Aqueous Solutions (owner) AQS-MFG-ROLL-HD01
ROLL fabrication drawing HD01 (AQS-PLAN-006 M3; graph revisi
Type: fabrication drawing (GA / nozzle orientation / part sheet) Rev 8880561d Issued
Created: flow graph pipeline Approved: not approved (study)
Sheet 1 of 1 AQS-DWG-001

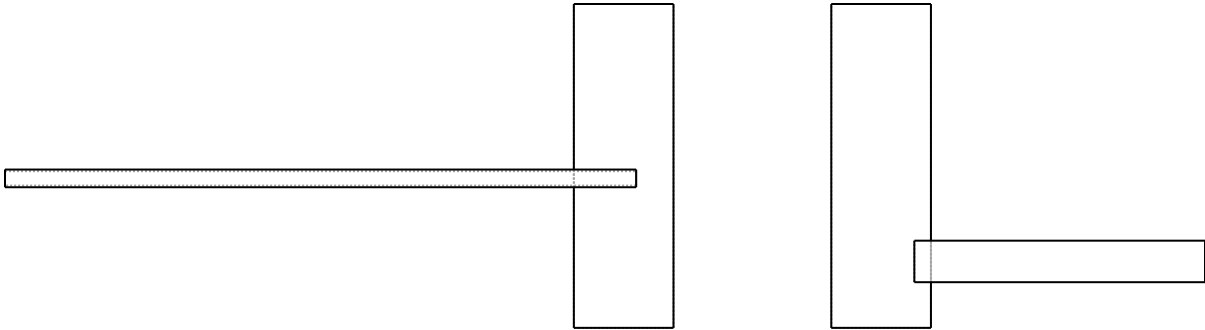
Graph revision AC - hd01: Screw-down OD 50, z 1150..1500, from the top-roll chock to the frame datum
Graph revision AC - hd01: Roll chocks cross the stand +X face by 20 mm (no coplanar seam); N5 vent riser DN15 to z 800
Graph revision AC - hd01: General tolerance ISO 2768-m unless noted
